ADDENDUM NO. 1

LIBERTY AND WESTCHESTER INTERMEDIATE SCHOOLS - ATHLETIC SITE PROJECTS Chesterton, IN 46304

ADDENDUM ONE

Addendum One (AD.01) to the drawings and specifications prepared by Gibraltar Design for **Liberty and Westchester Intermediate Schools Athletic Site Projects** for Duneland School Corporation, Chesterton, Indiana.

S-103 LIS

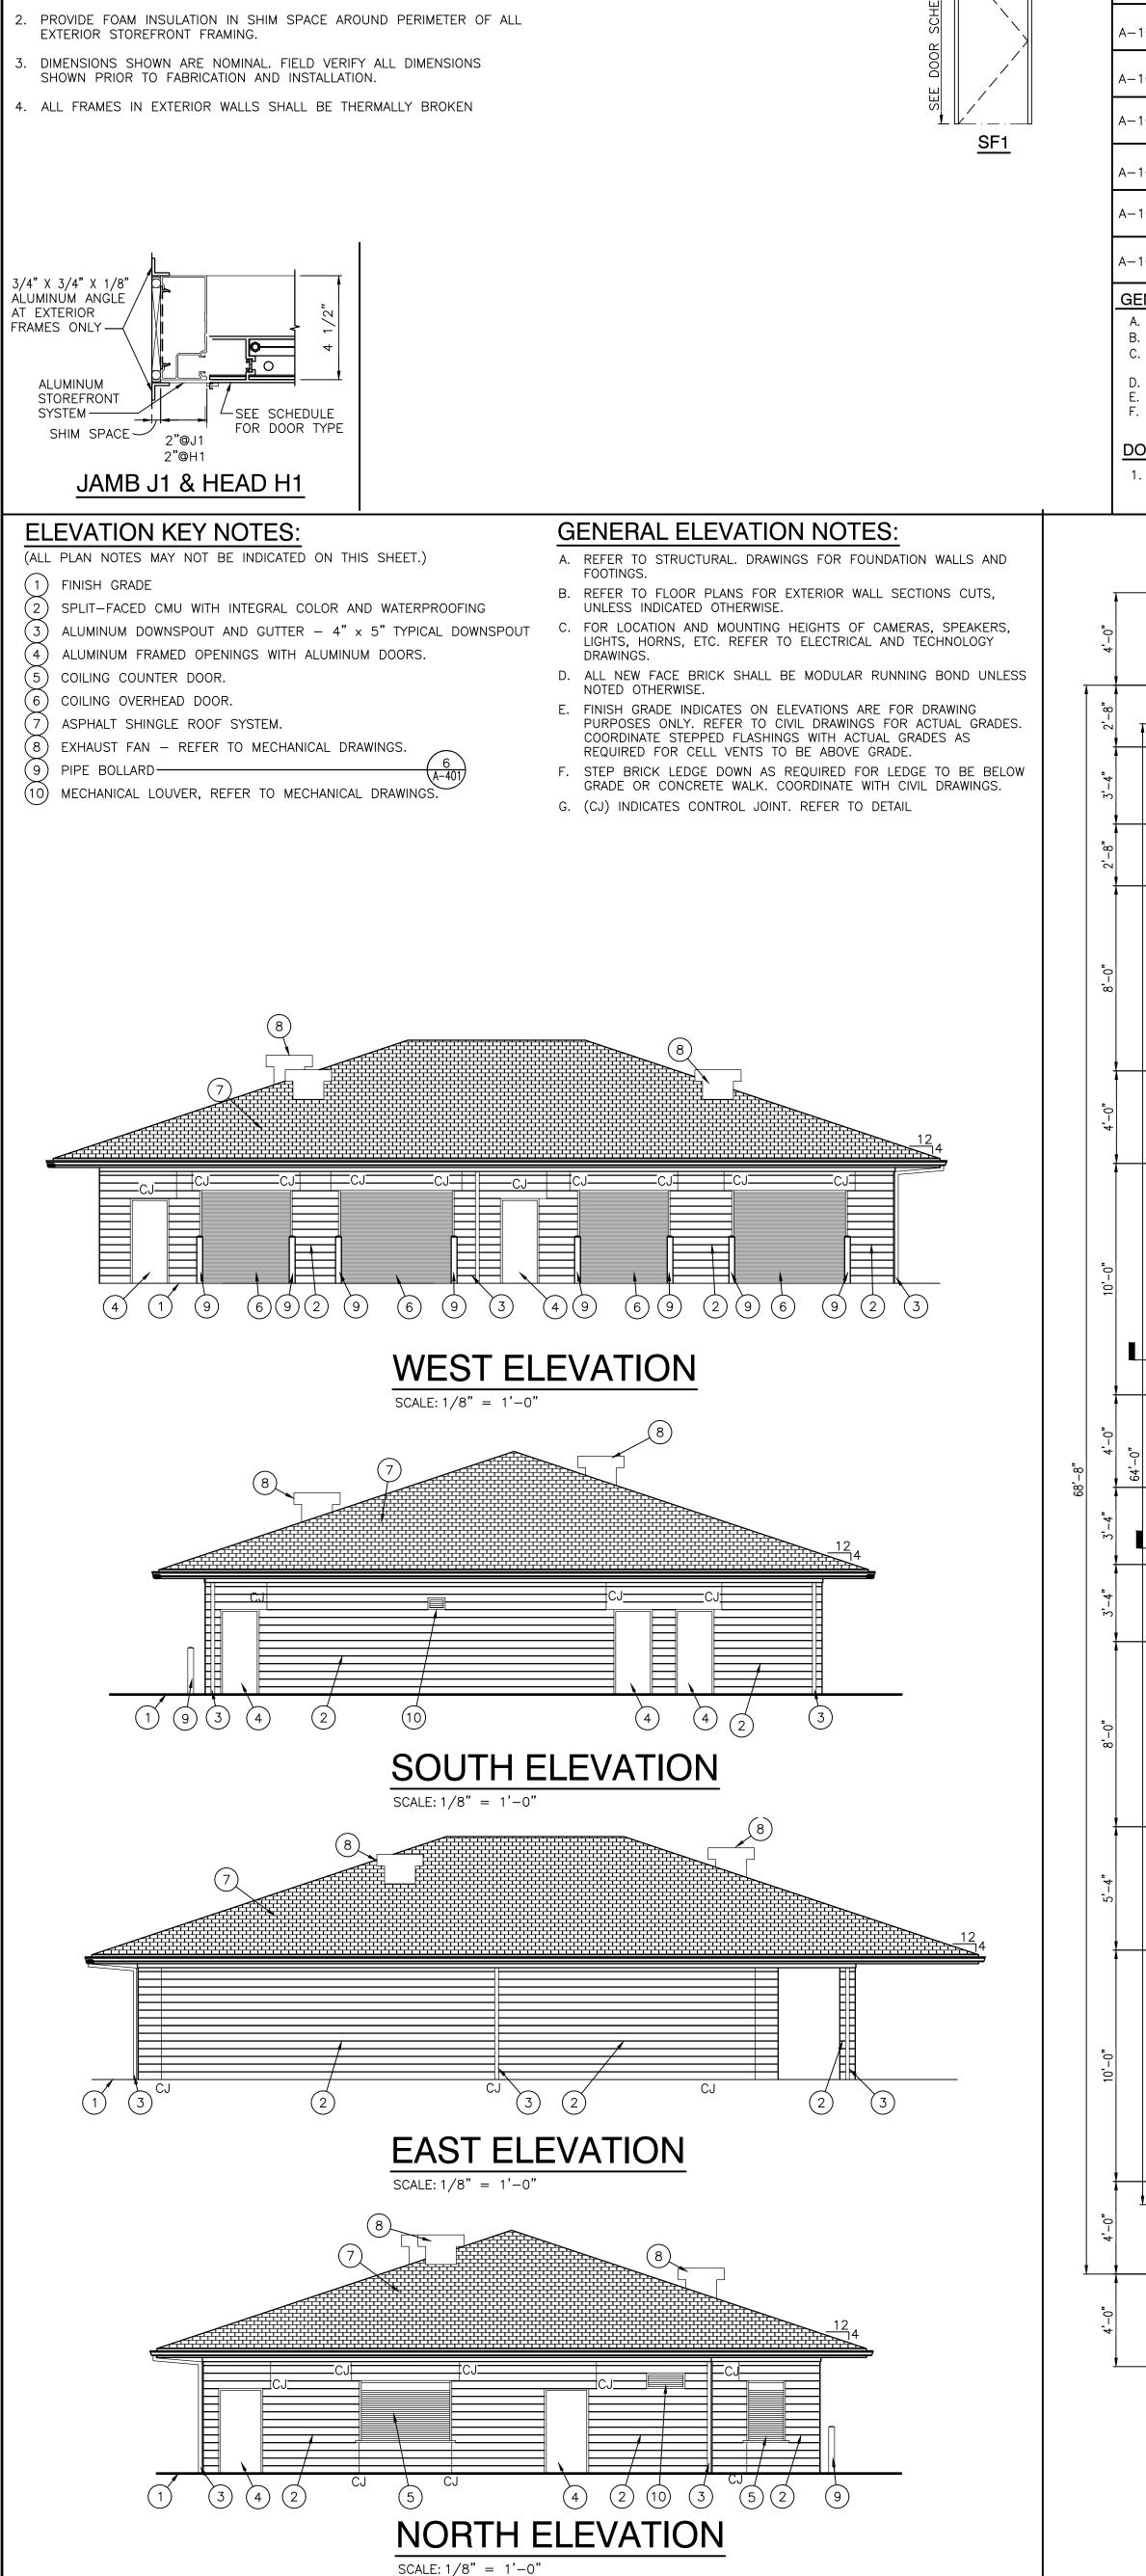
4. Sheet S-101 LIS and S-103 LIS

A. Refer to two (2) revised full-size drawings, included in this Addendum, for revisions.

A-102

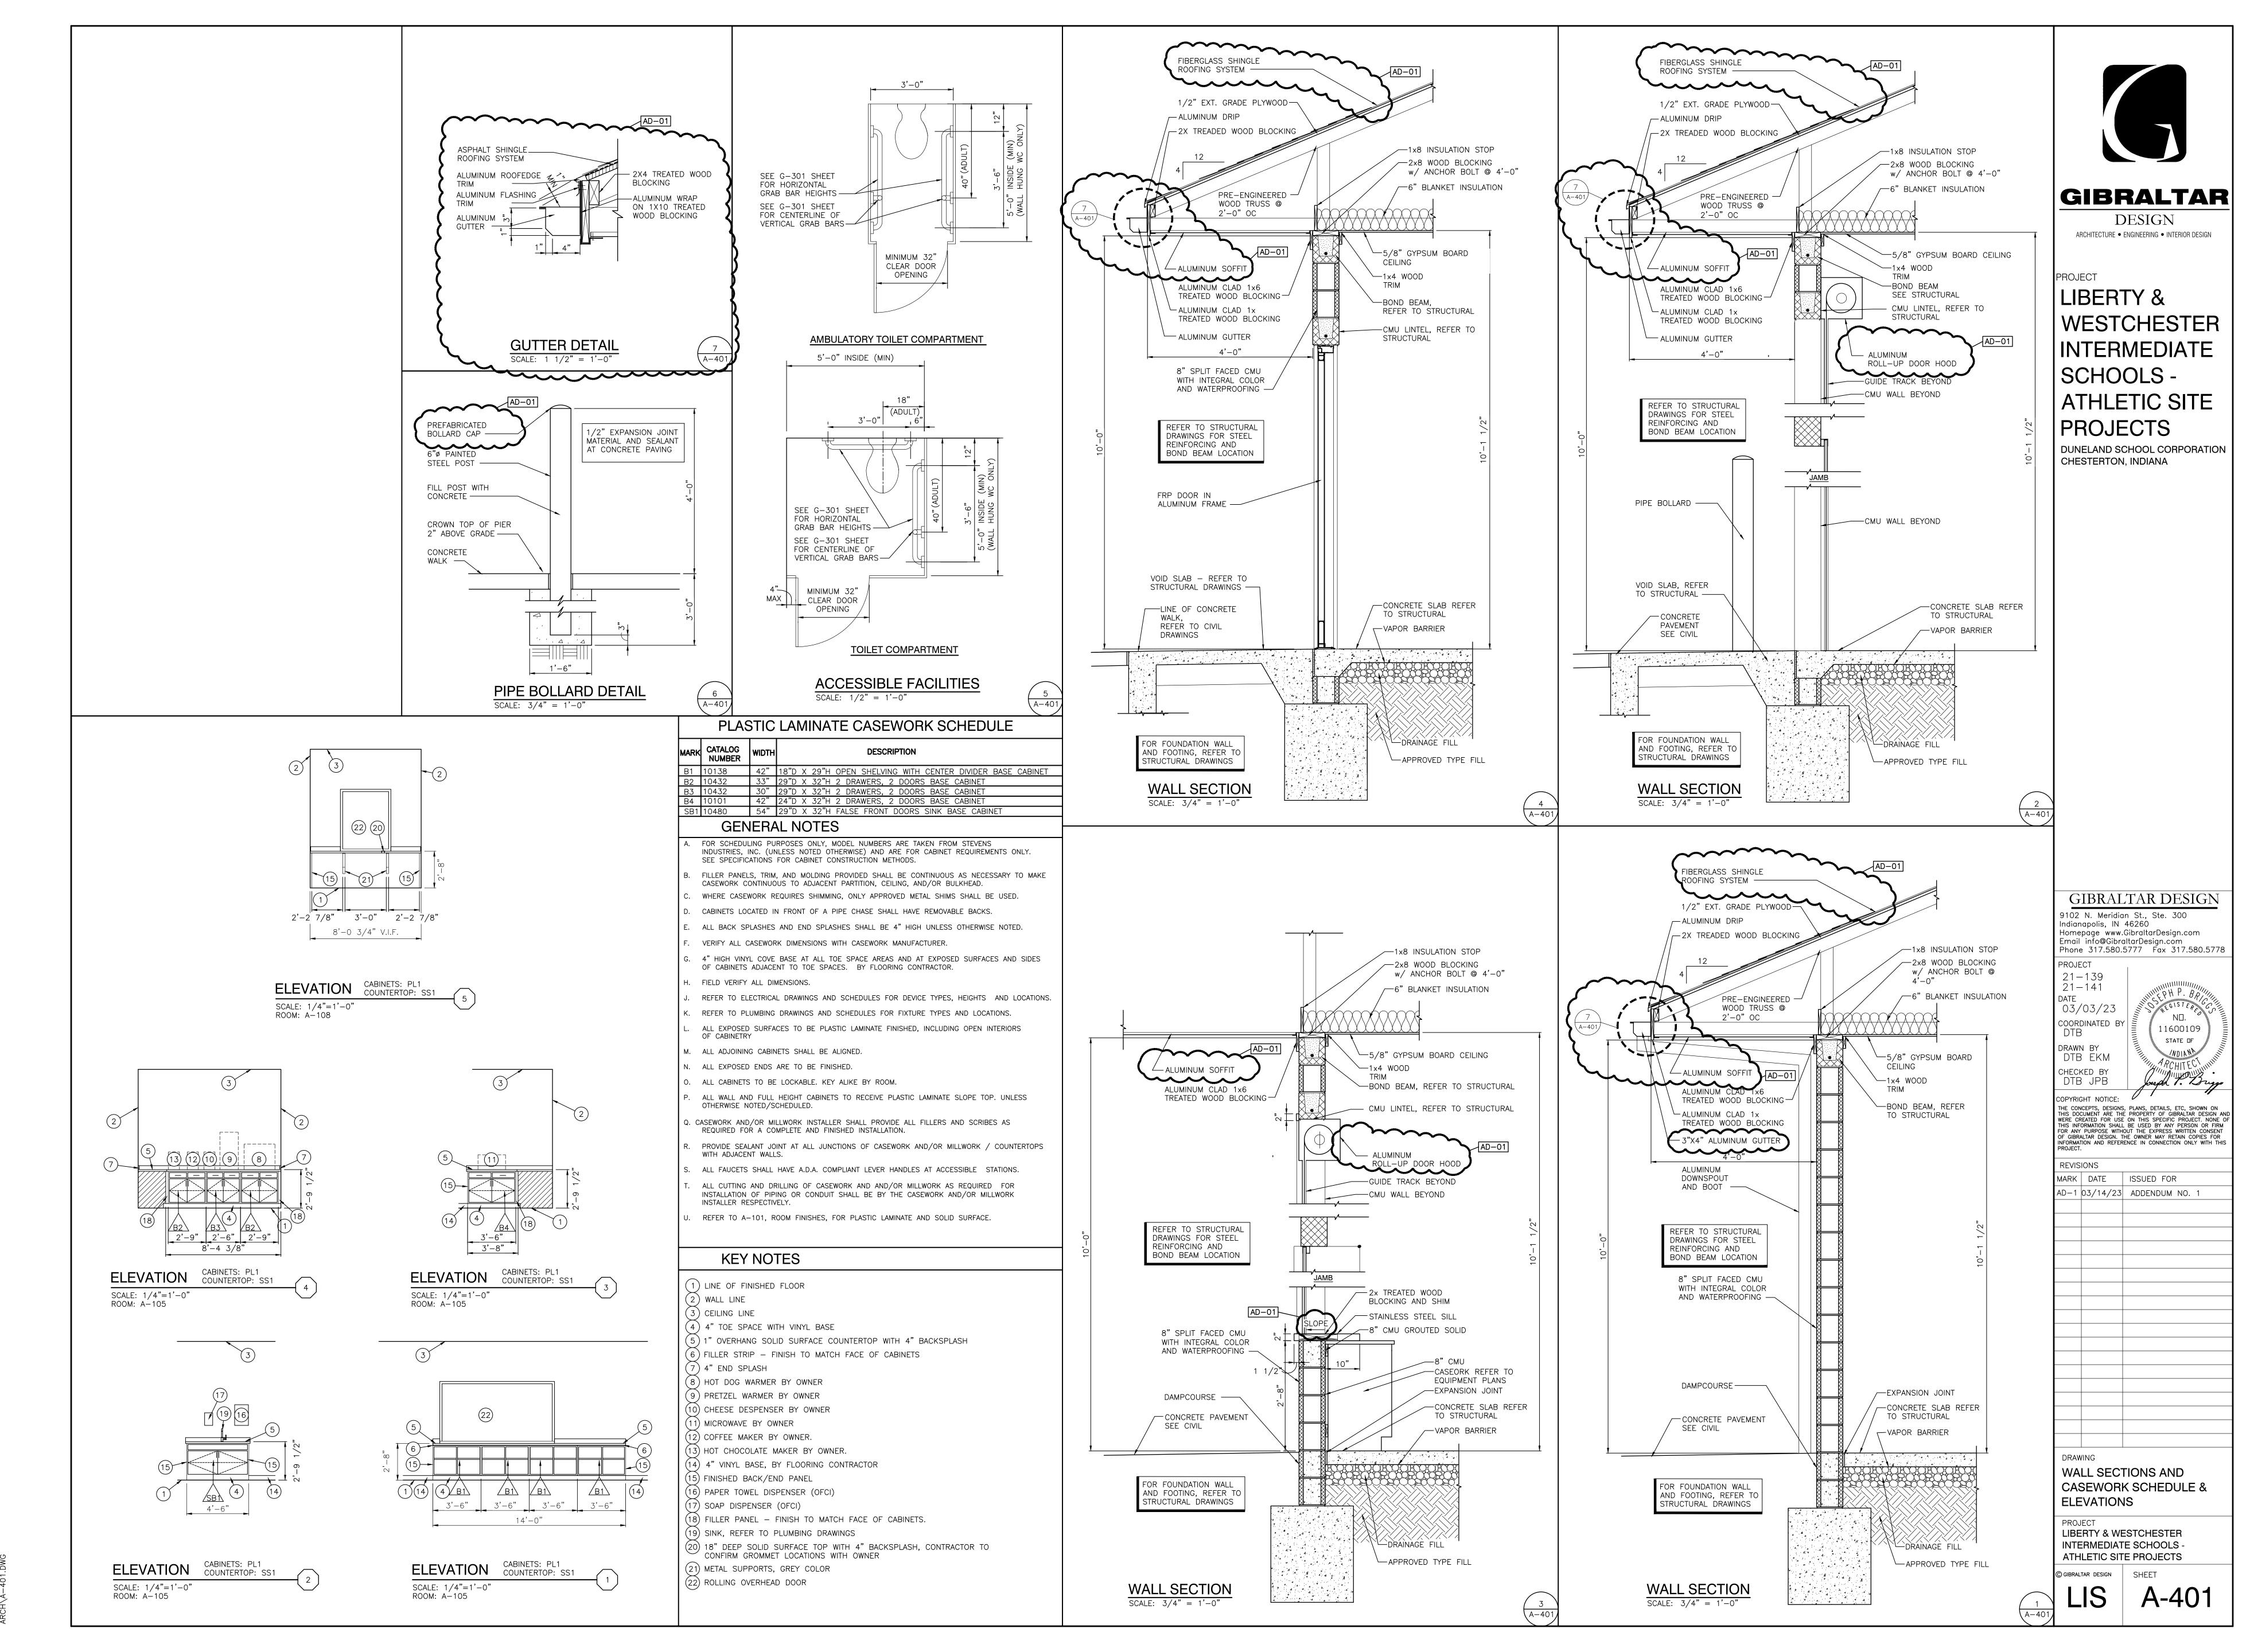
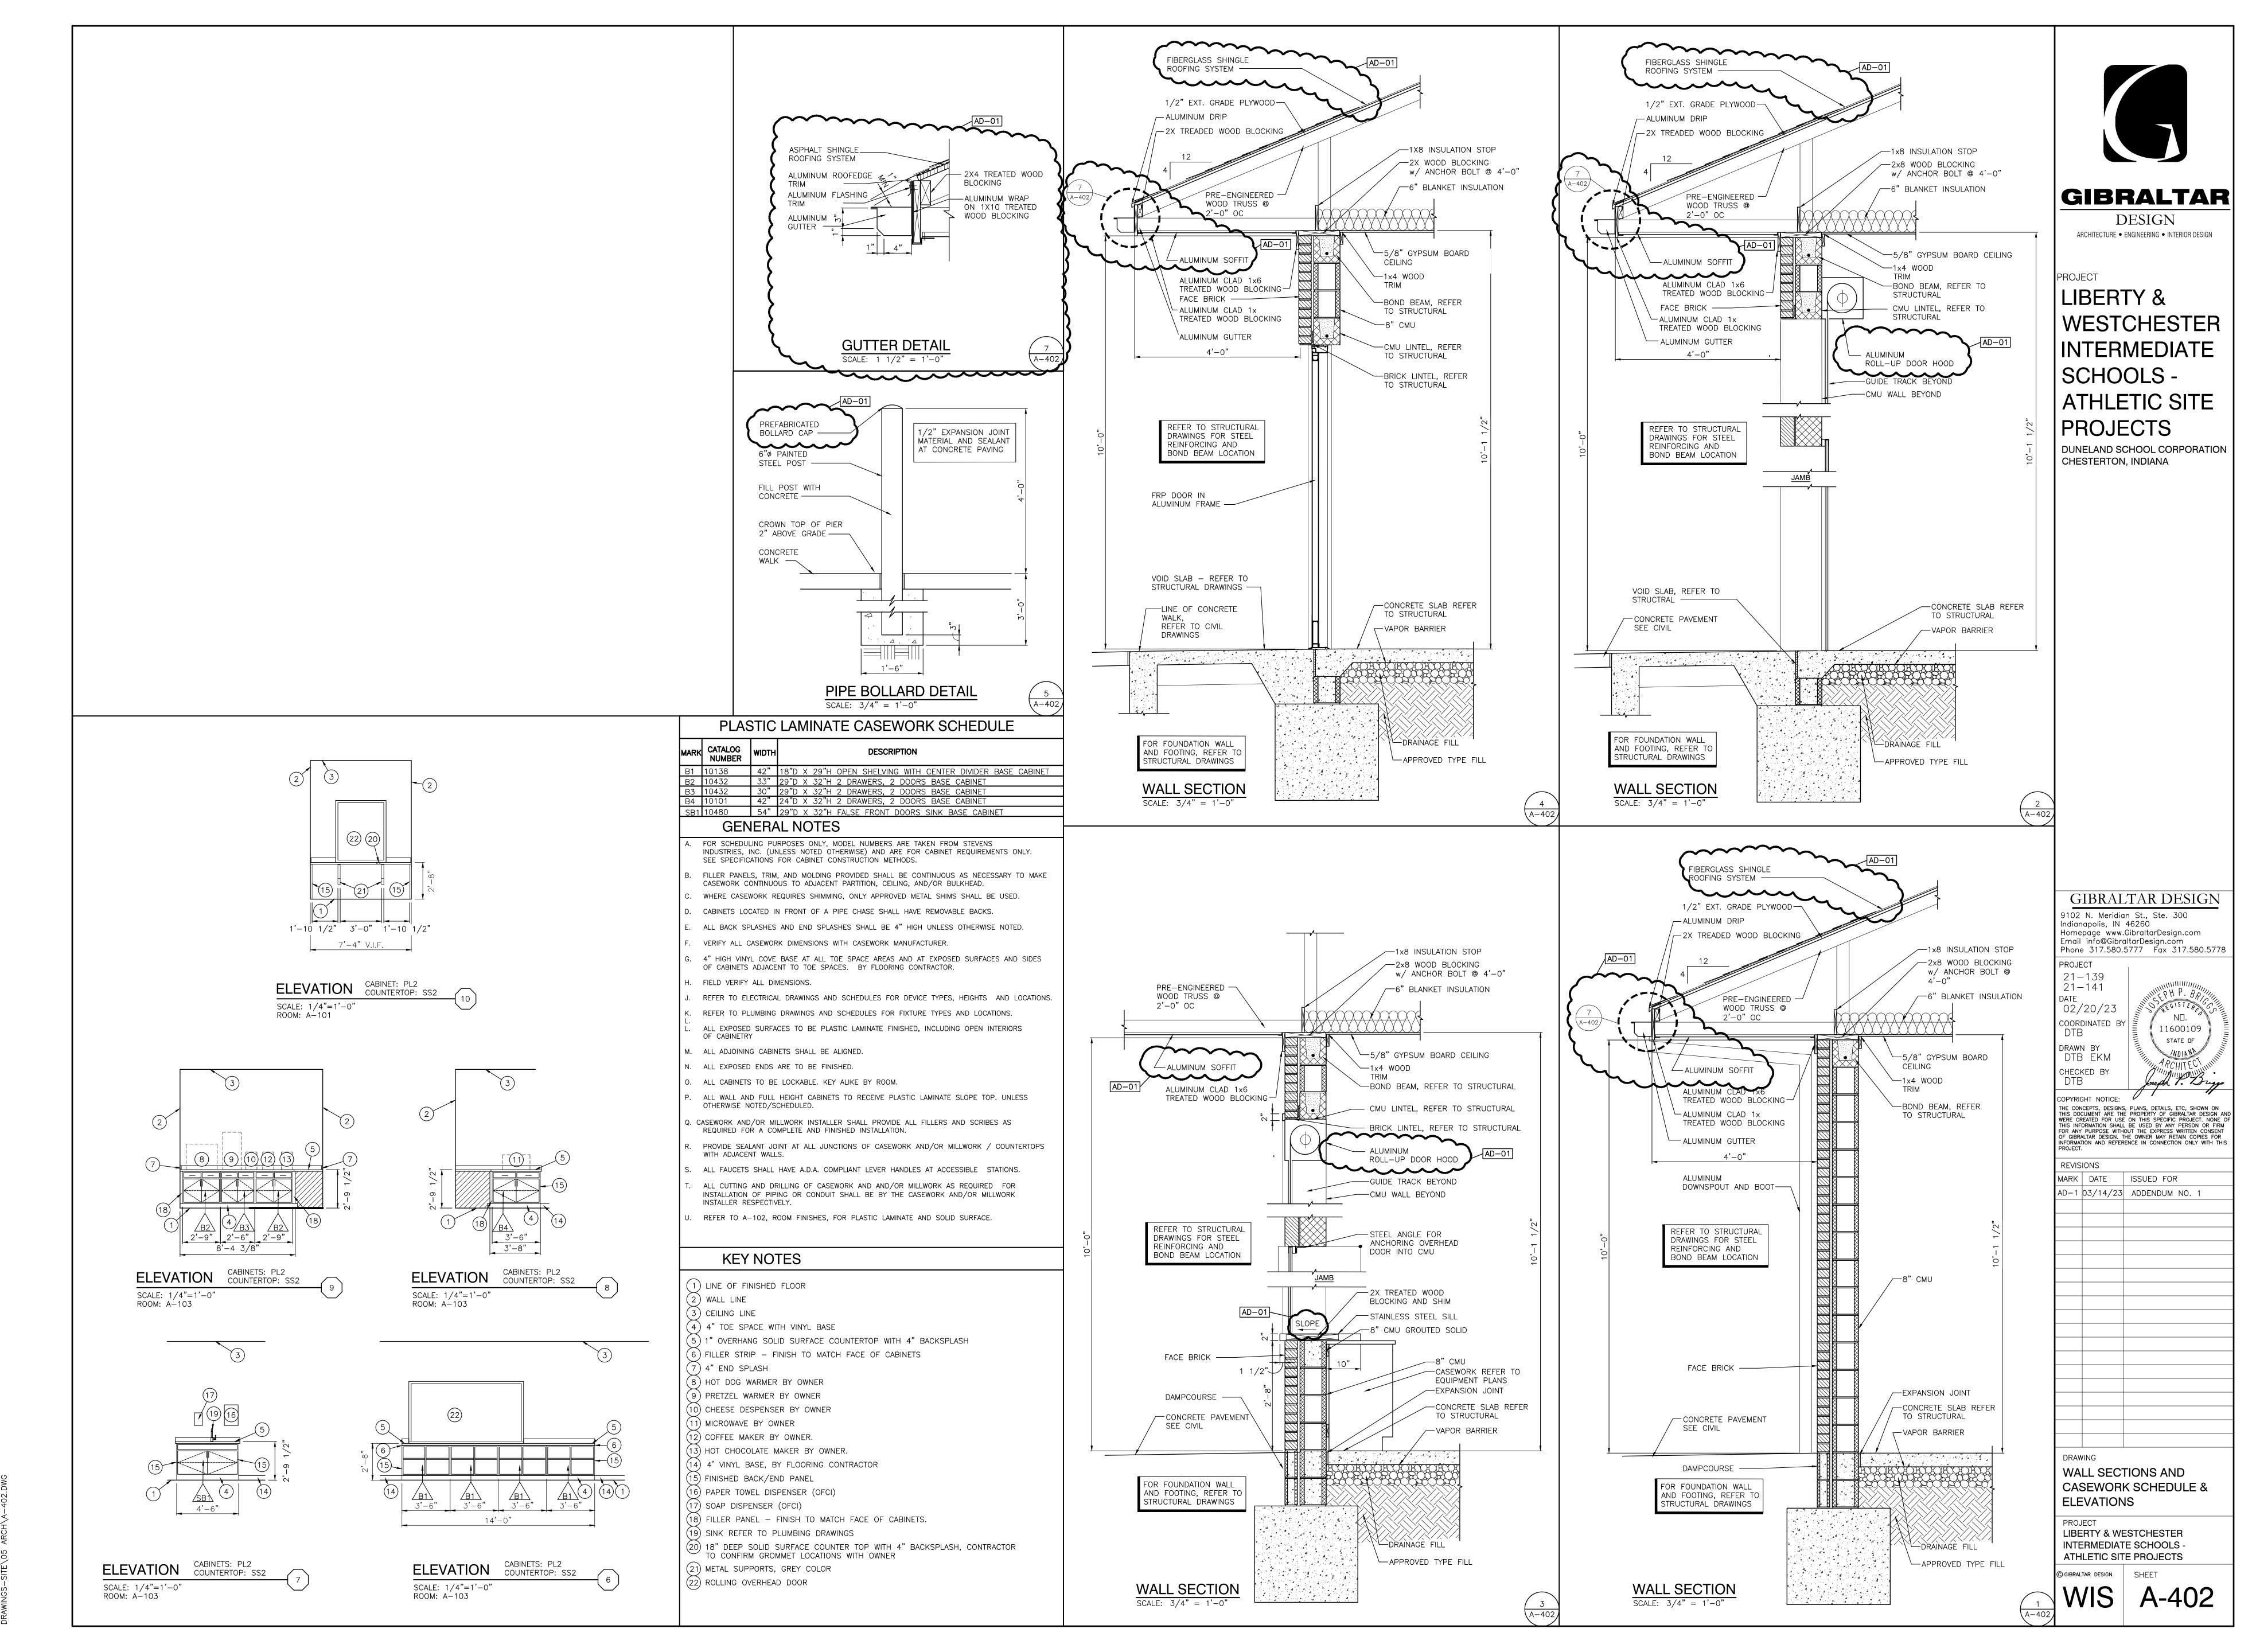
6. Sheets A-401 and A-402

- A. Refer to Two (2) revised full-size drawings, included in this Addendum, for the following revisions:
 - 1. Revise Sections 1-4.
 - 2. Revise Detail 6 "Pipe Bollard Detail".
 - 3. Add Detail 7 "Gutter Detail".
